Ref: SSD-81890707

RE: SUBMISSION TO SSD-81890707 Nos. 10, 14 AND 14A STANHOPE ROAD, KILLARA

Ku-ring-gai Council's objection/submission to SSD-81890707 at 10, 14 and 14a Stanhope Road, Killara).

Figure 6: Excerpt from western elevation showing rectilinear design and lack of podium

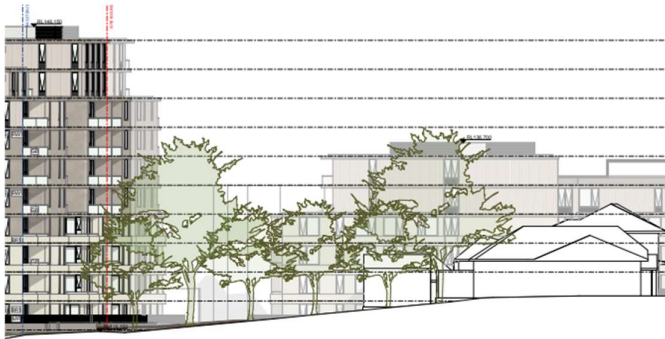
The proposed flat building has an eight storey rectilinear sheer high wall which is notably different in scale and contrast to the two storey heritage building at No. 12 Stanhope Road and contributory building at No. 8 Stanhope Road.

As proposed, the development does not respond to adjoining low density development and is inappropriate (**Figure 6**).

Figure 8: Possible location for visitor bicycle parking

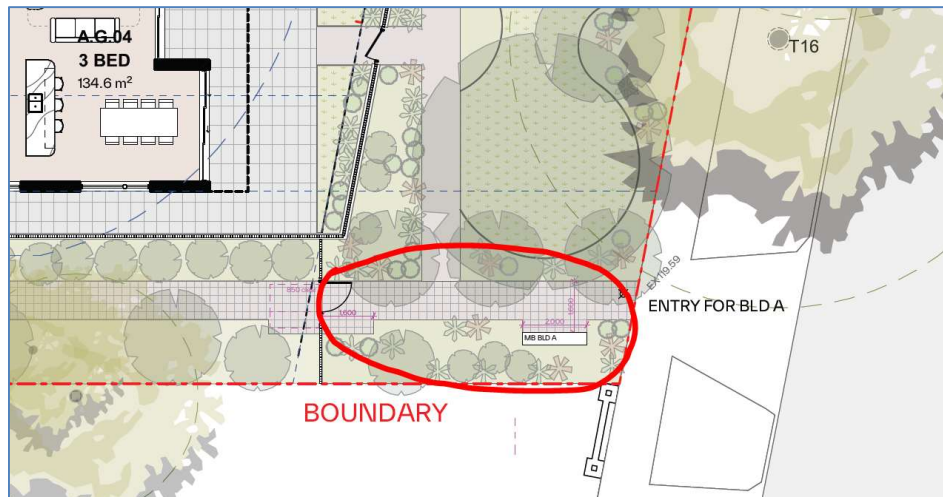
According to the architectural plans, visitor bicycle parking is proposed to be located on the Lower Ground 1 level and Lower Ground 2 level. Similar accessibility issue to residents arise (as noted above), and given the additional practicality of visitors entering the secure parking area to access the bicycle parking from the main entry ramp, it is recommended that the visitor bicycle parking be relocated to somewhere near the pedestrian entry area for Building A and the pedestrian entry area for Building B and C as shown on the Ground Floor plan, in accordance with AS2890.3 (circled in red) (**Figures 8 and 9**):

Figure 10: Inaccessible bin holding room on Lower ground level 1

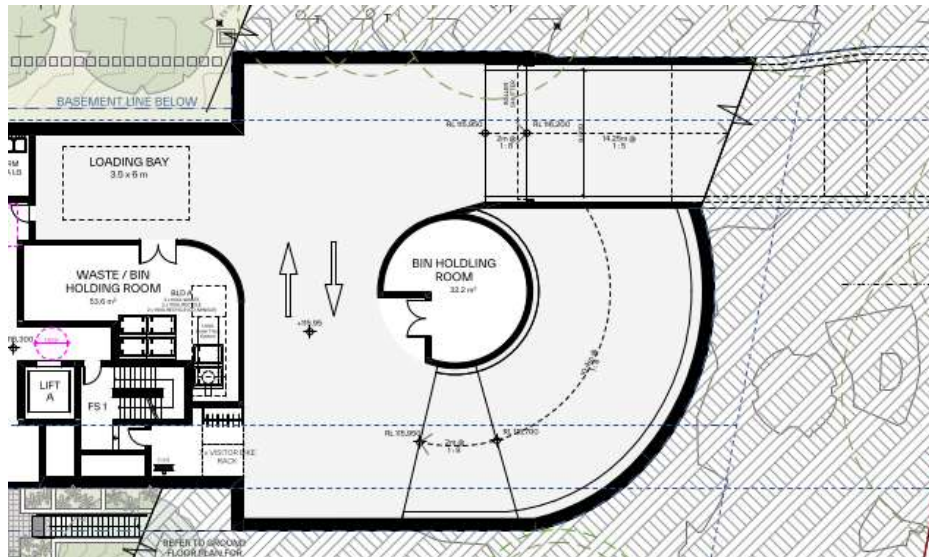
Concern is raised regarding the safety and practicality of the bin holding room with the ramp on Lower ground level 1 (**Figure 10**). This room must be relocated.

1. Drg. Stormwater Management Plan C3 Rev C states:

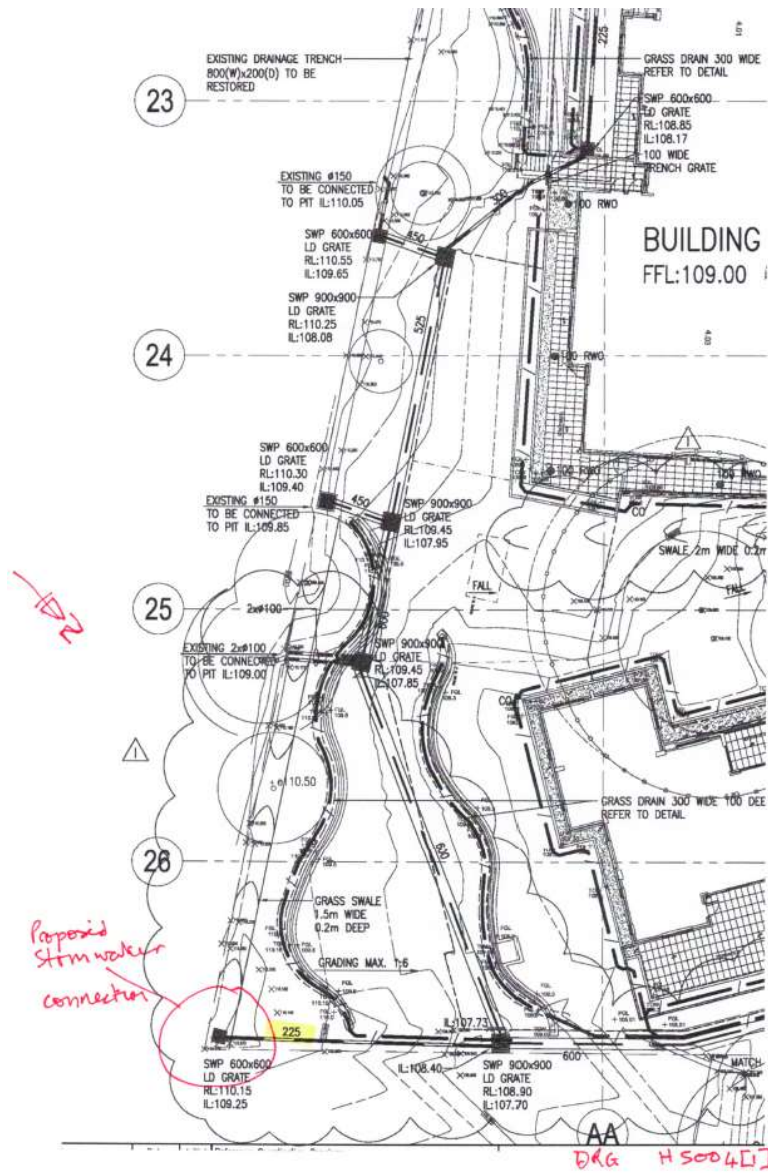
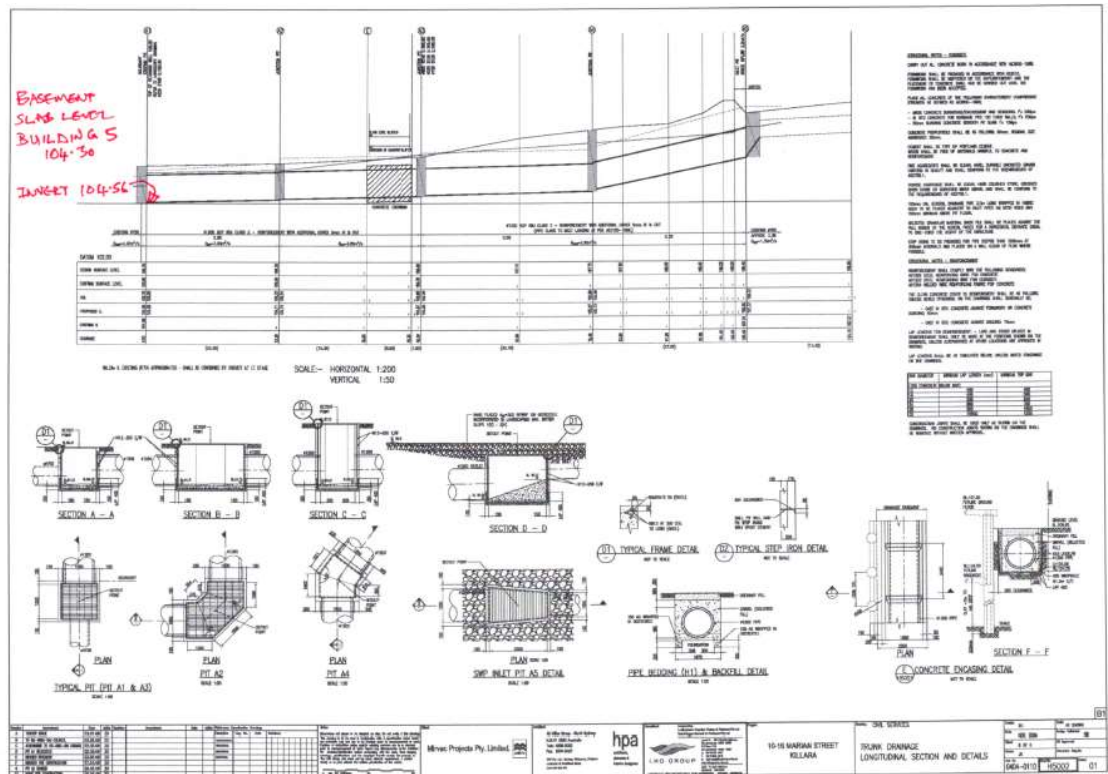
*“Discharge to existing 300 dia pipe & pipe network in 10 Marian Street” and
“Discharge stormwater to existing inter-allotment drainage pit...”*

There is no easement to discharge to 10 Marian Street and no likelihood of one being agreed as the owner of 14 Stanhope Road conceded prior to his recent rebuild.

There has been no written request for an easement either.

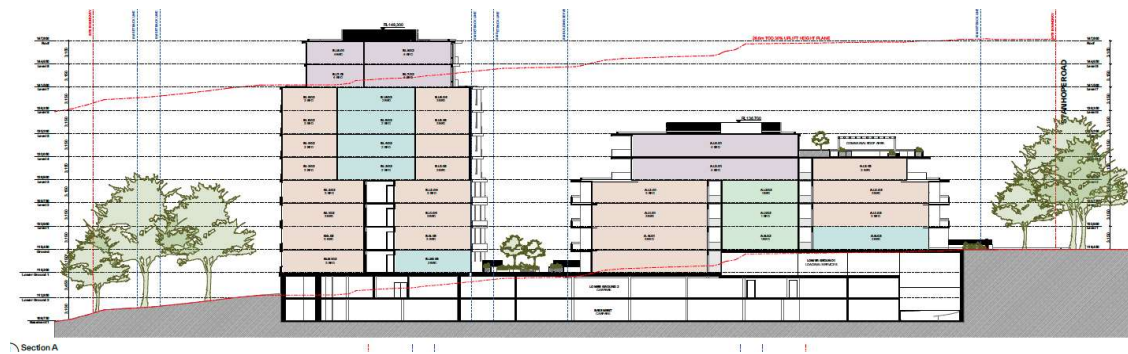
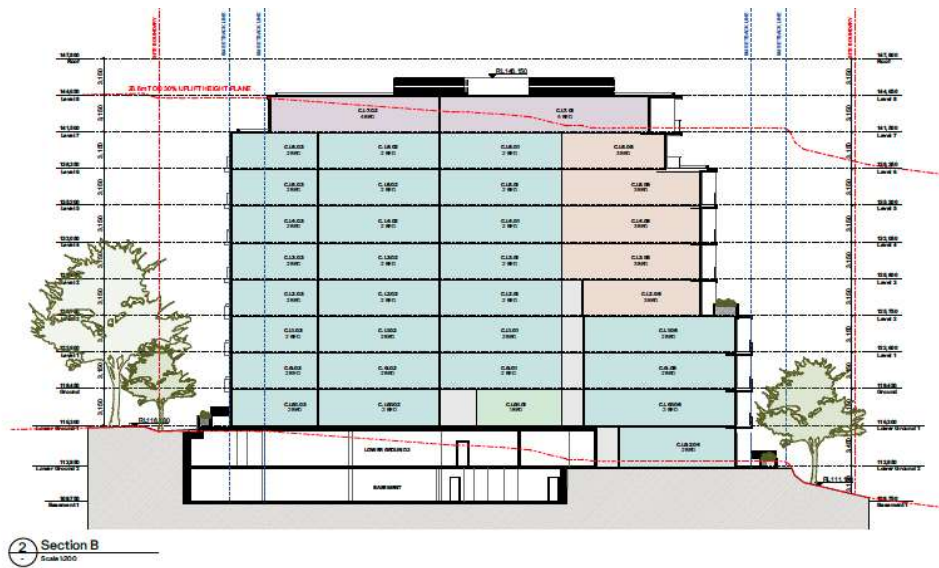
Section 1, Introduction, confirms that the height of buildings is to be measured from existing ground level and states that the Proposal, without a variation request, would be 28.6m high.

It also confirms that the request includes “*using the existing topography of the site*”.

The architectural drawings appear to disregard this criteria in certain locations and measure from the final landscaped embankments.

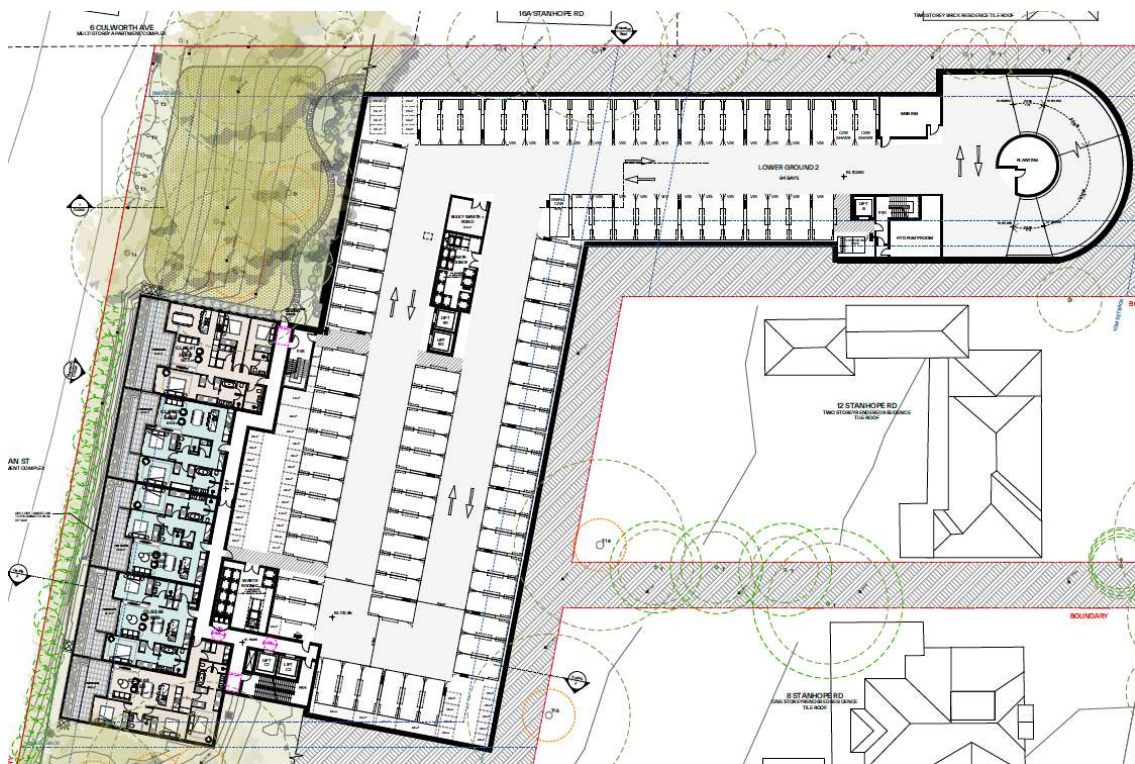
Item 15. All parking bays are to be EV ready with design and construction (provision for conduits, switchboards, electrical capacity etc) to enable installation of electric vehicle charging points that are linked to each individual dwelling electricity meter

It is not clear how, or even if it is practical or safe to provide access to chargers to the rows of single spaces in the middle of the parking floors.

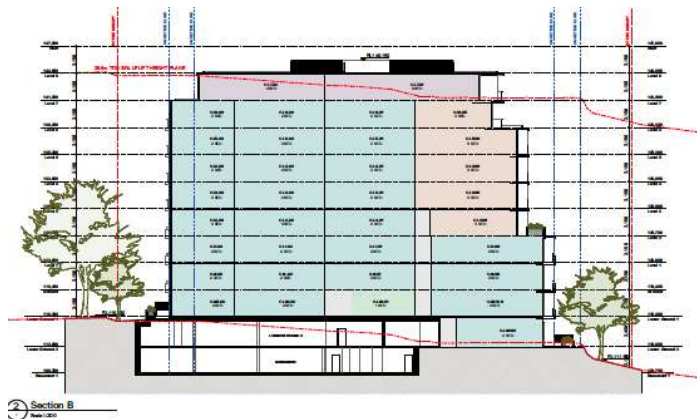
Page 36. The North Elevation is the one facing the residents of 10 Marian Street. The new embankment to Block C is clear and elevates the ground floor above the lower car parking level.

Page 38. Section A is shown, but critically they have not shown the Section B. Both are shown on the same Drawing, DA 300 Rev 1. See Extract of Section B below:

Further, Section A shows 2+ levels of car parking. As mentioned above, this is contrary to the Page 6 Project Background consent request for 1.5 levels.
